PLANNING BOARD AGENDA
AUGUST 11, 2022 – 7:00 P.M.

2. Liberty New York Water – 23 MacArthur Drive	54.20-1-42		7/29/22	Site Plan
--	------------	--	---------	-----------

**Re: Liberty New York Water
Wellhead Treatment at West Branch Acres
H2M Project No.: NYAW2105**

PROJECT NO: **C 100.00**

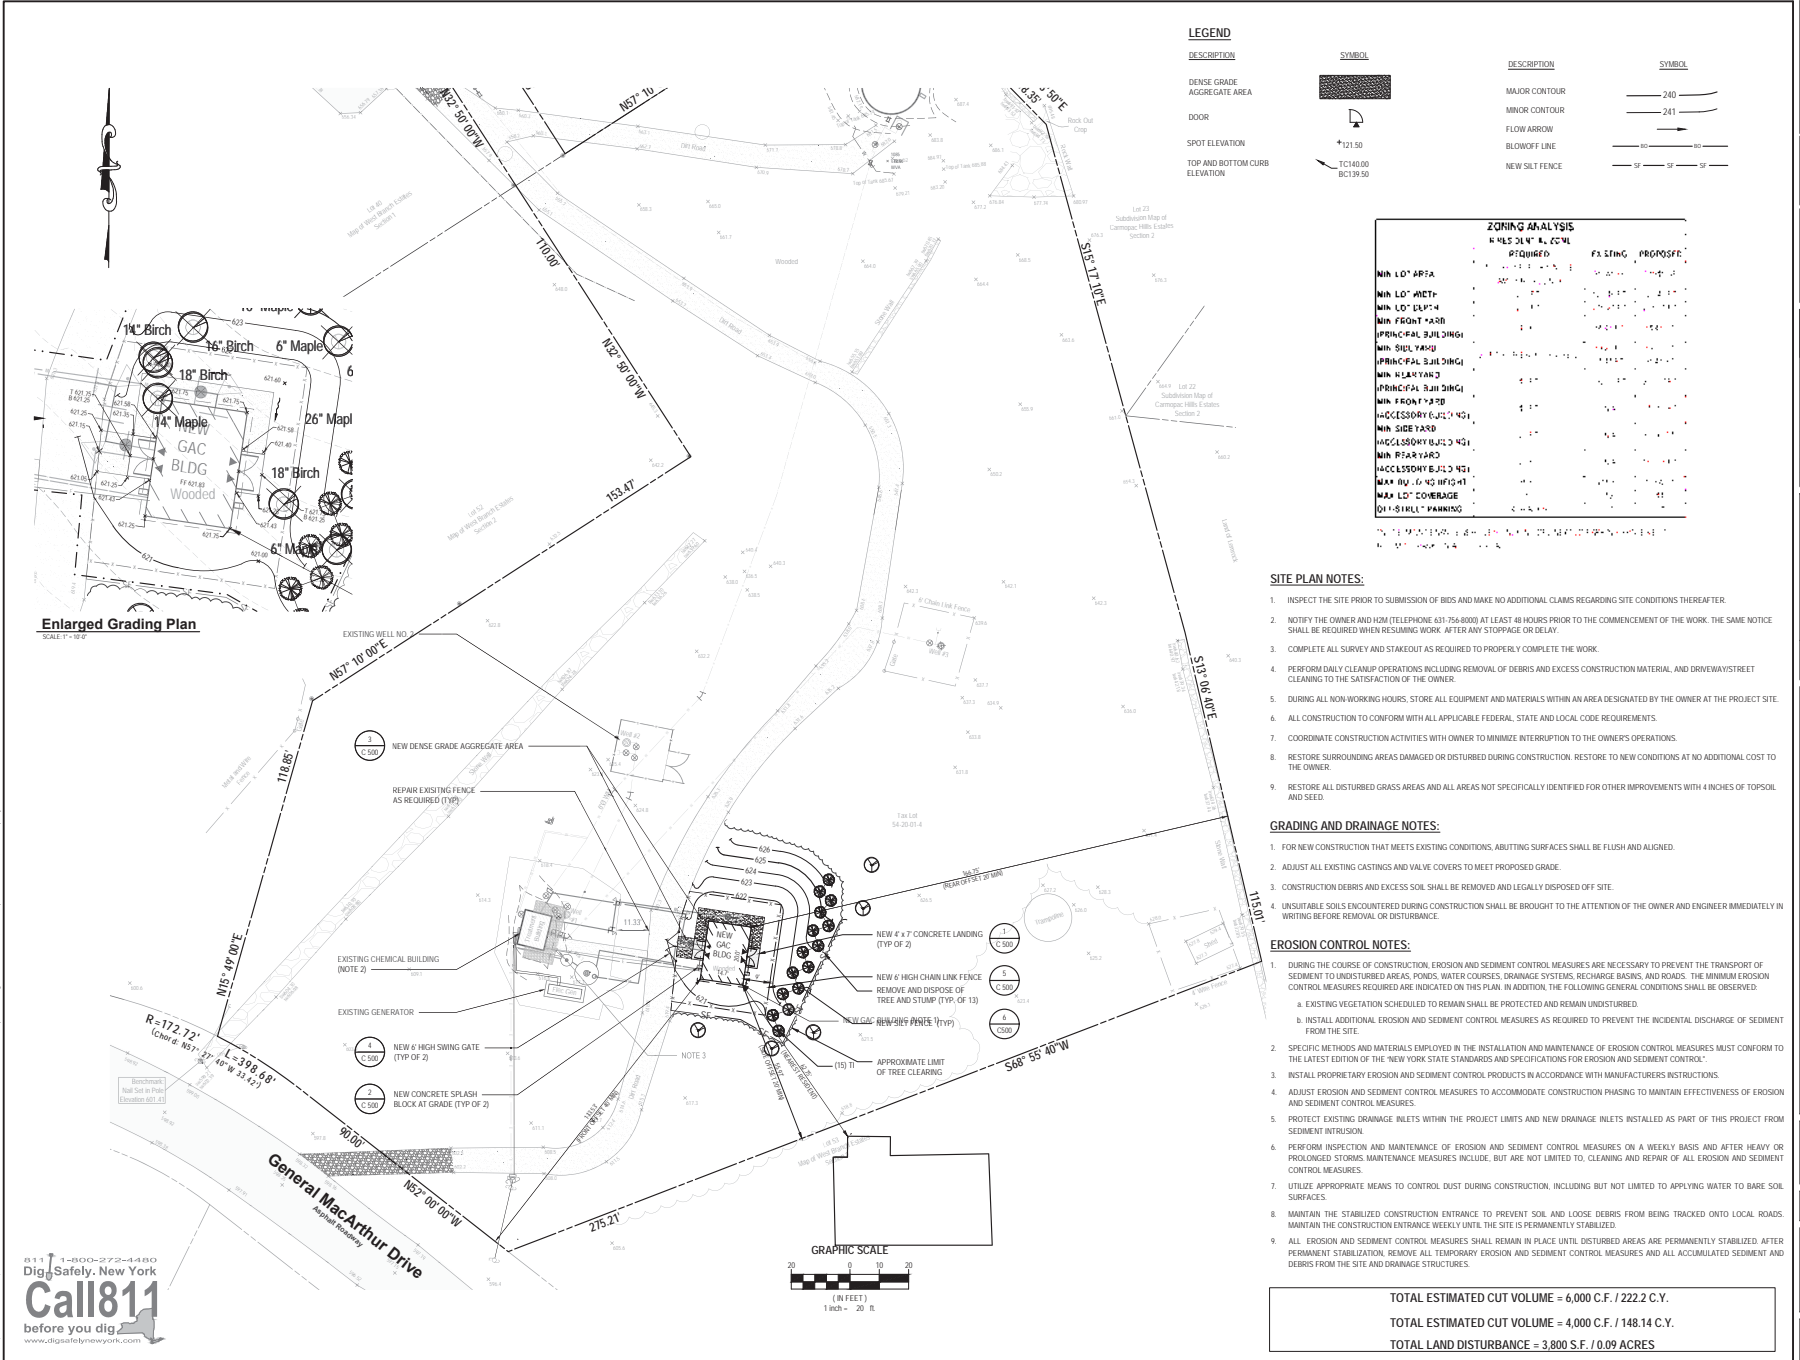
3. *Provide a zoning table to show compliance with the zoning requirements. If there are any non-conformities, variances will be required from the ZBA.*

4. *All regrading required to accomplish the intended development has been provided. It is unclear from the drawings provide the extent of cut and fill proposed for the site.*

4. *The area of disturbance must be shown on the drawing and delineated by orange construction fencing.*

2. *The new GAC building is proposed to the east of the existing building, across the existing driveway. A zoning compliance table, and the building envelope should be indicated on the site plan. It appears that the proposed building meets all dimensional setback requirements.*

6. *Clarify the distance of the proposed building to the closest residential neighbor.*

Response: Please see the enclosed revised site plan, C 100.

Response: Please see revised site plan C 100. Roughly 6000 cubic feet of soil is proposed to be removed and roughly 4000 cubic feet of fill is proposed.

Response: Please see the site plan, C100. The area of disturbance is shown in a bold dashed line. A comment has also been added to the plan to indicate the orange construction fencing needs to be utilized during construction.

Response: Please see the enclosed revised site plan, C 100.

Response: Please see revised site plan C100.

PROJECT NO.: **CL 100.00**

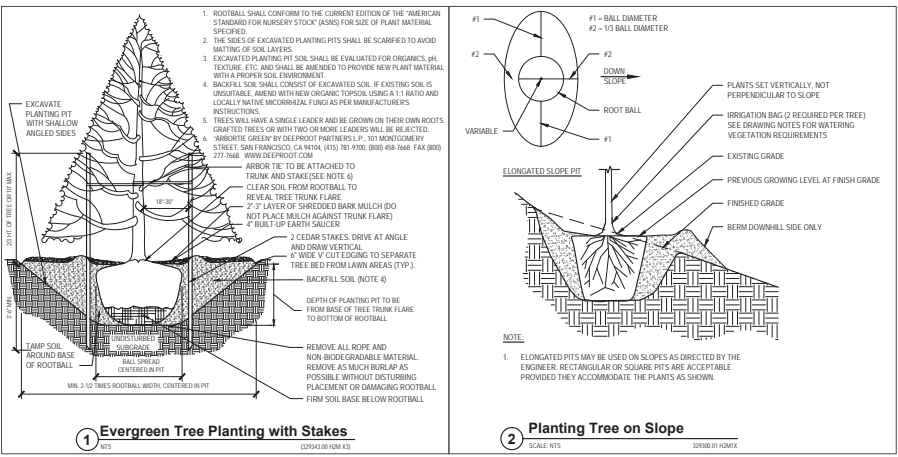
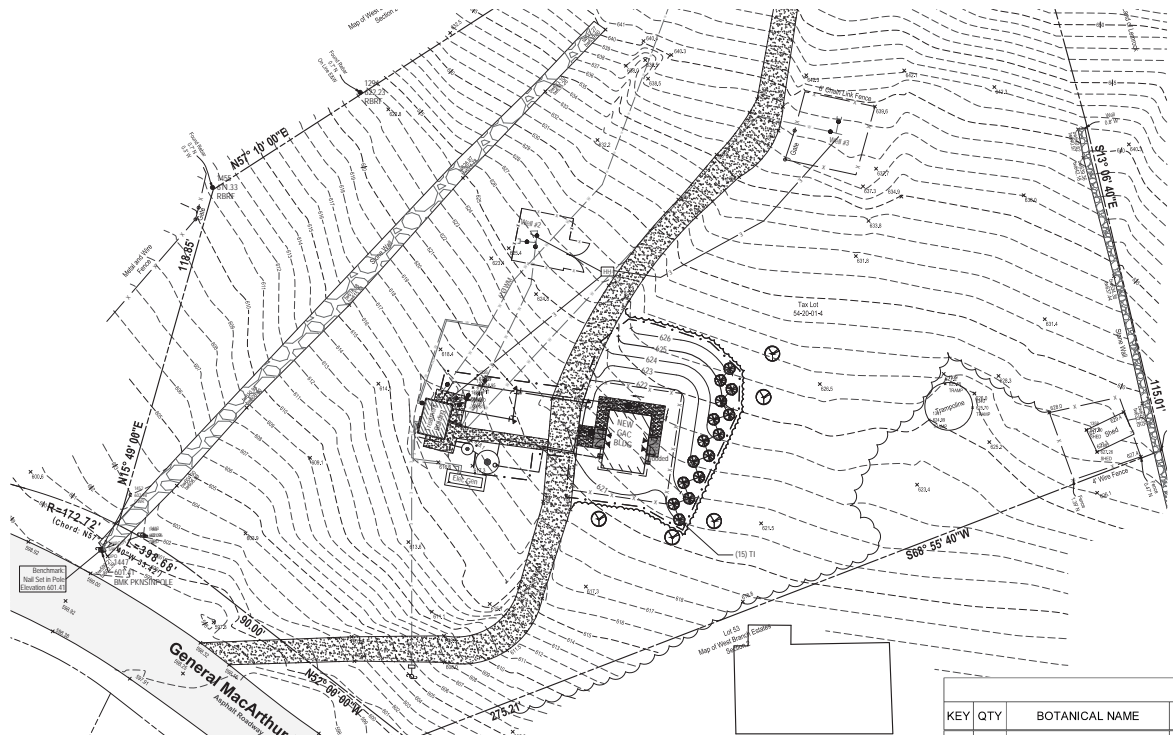
1. *A landscaping plan has been provided. The applicant should add a note the following:*
 - a. *All planting should be verified by the Town of Carmel Wetlands Inspector. Note should be added to drawing.*
 - b. *All plantings shall be installed per Section 142 of the Town of Carmel Town Code. Note should be added to drawing.*

Response: Please see the enclosed revised landscaping plan, CL 100.
